SSDA Mods

1.1 Facade Materiality

Modification 1 to SSDA

Proposed Modification: Axometric view of rooftop lightning rods

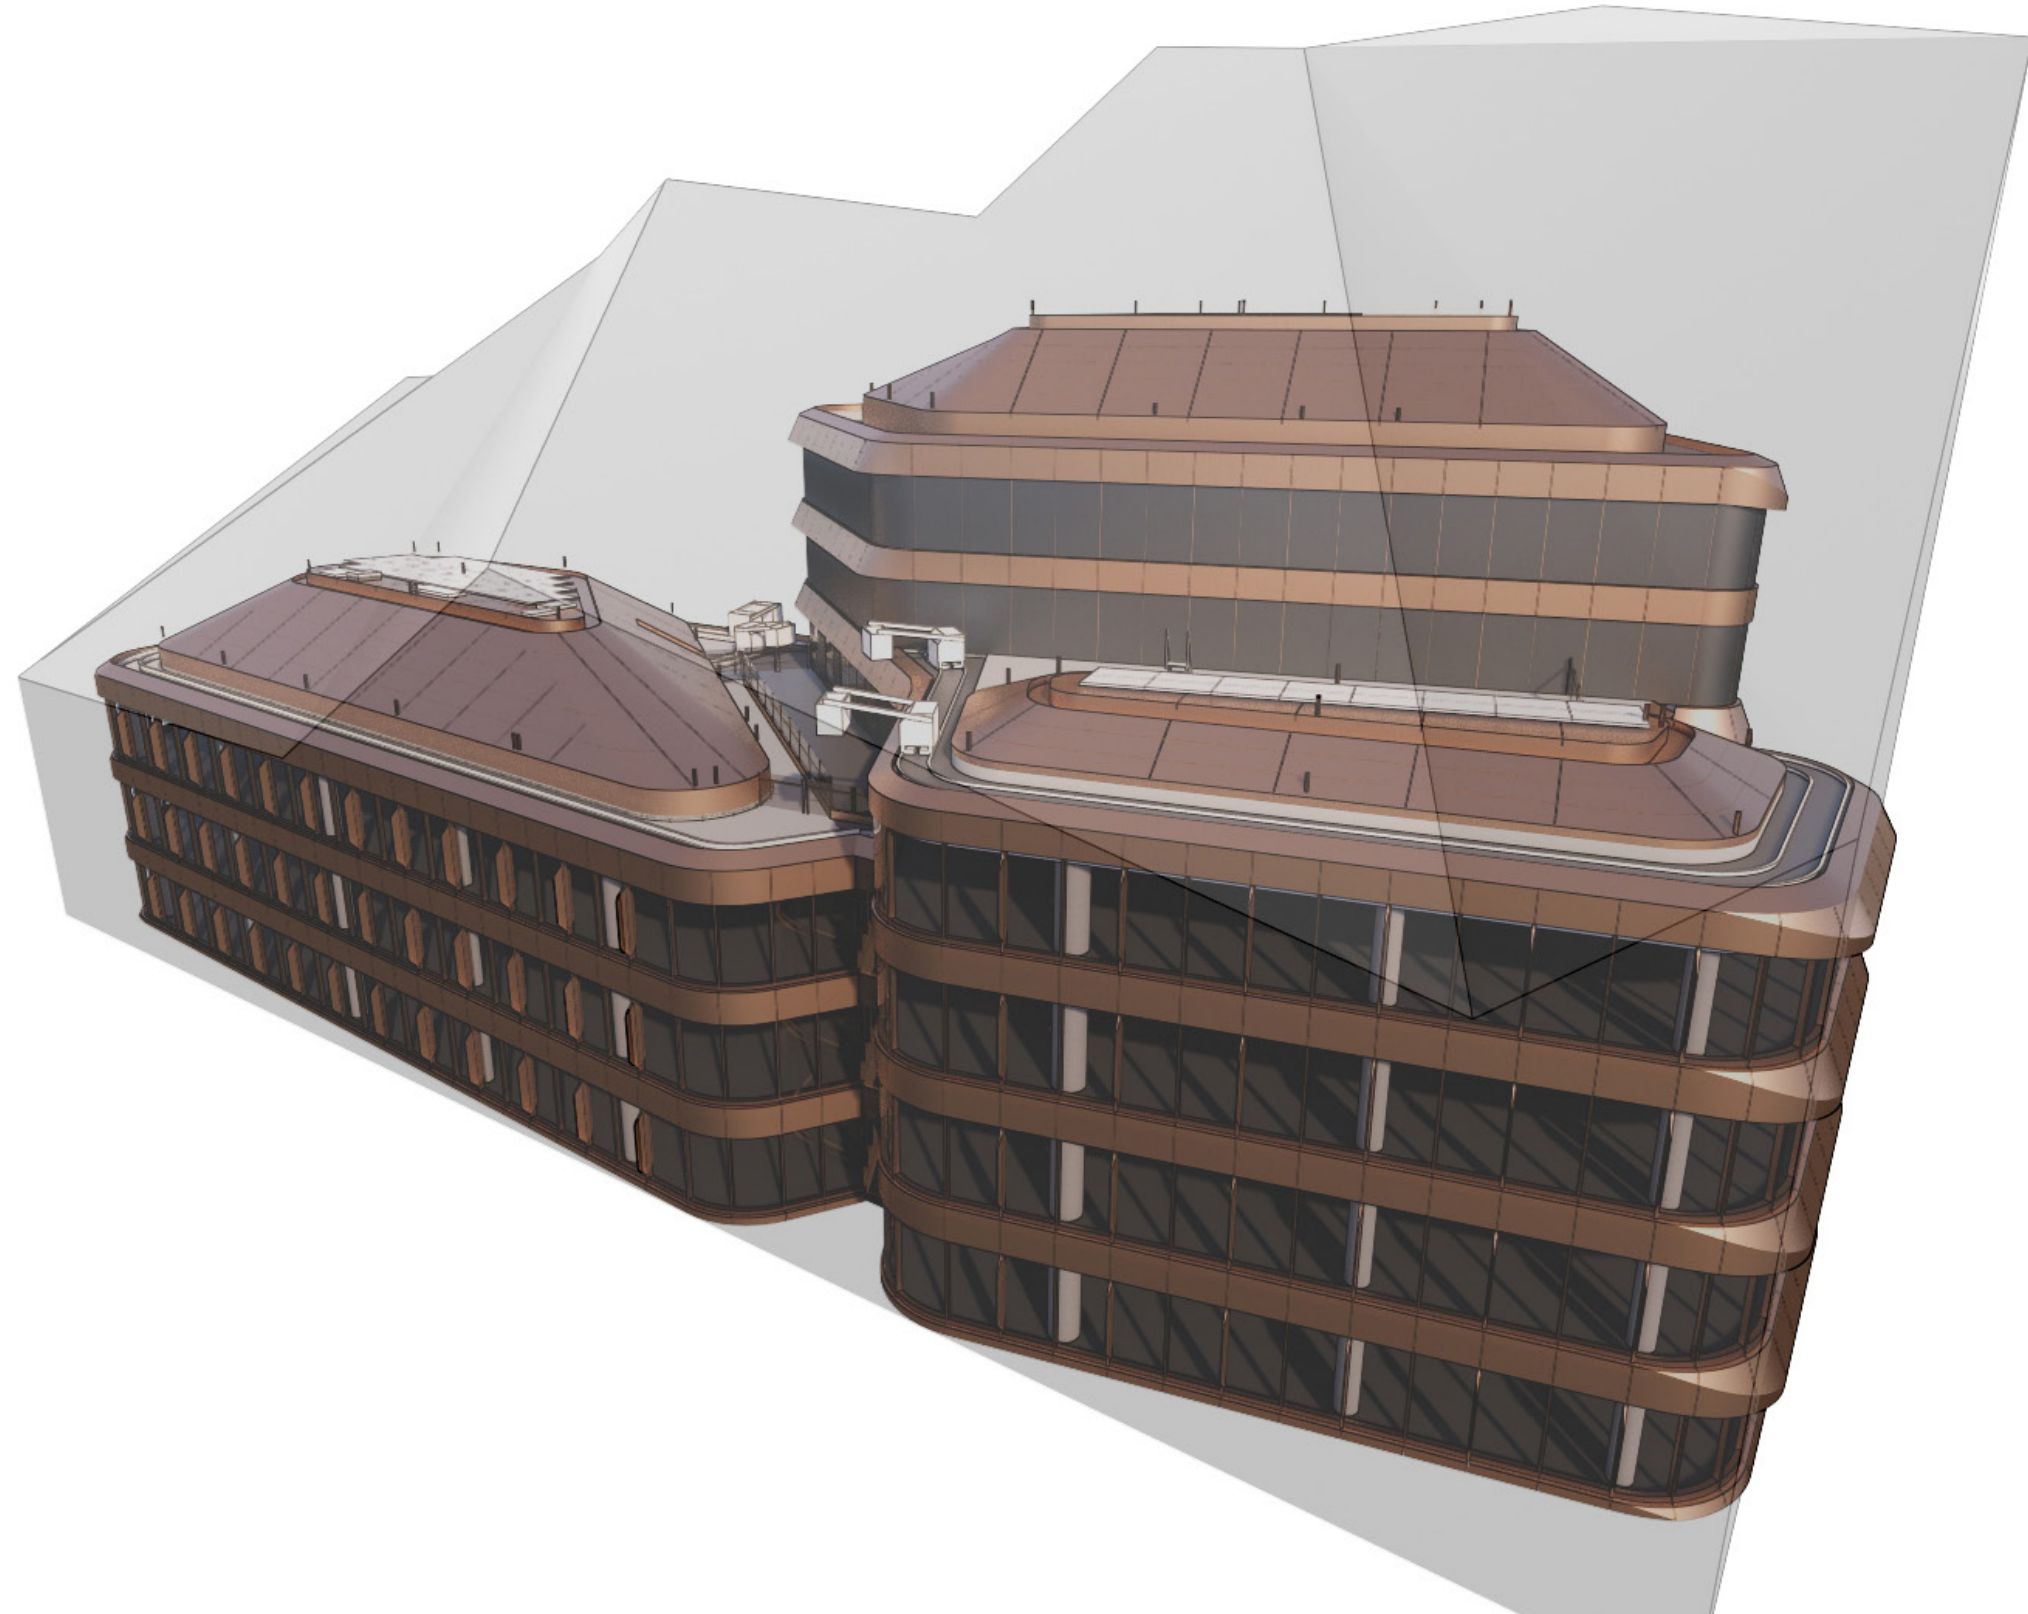
Clarification showing the air terminal extent is indicatively located over all roofs and may not exceed a maximum height of 1m above the respective roof RLs shown.

In the axonometric view shown, the air terminals do not protrude outside of the concept envelope. As the air terminals are extremely narrow and spaced well apart from one another, they will not have a negative effect on the aesthetics
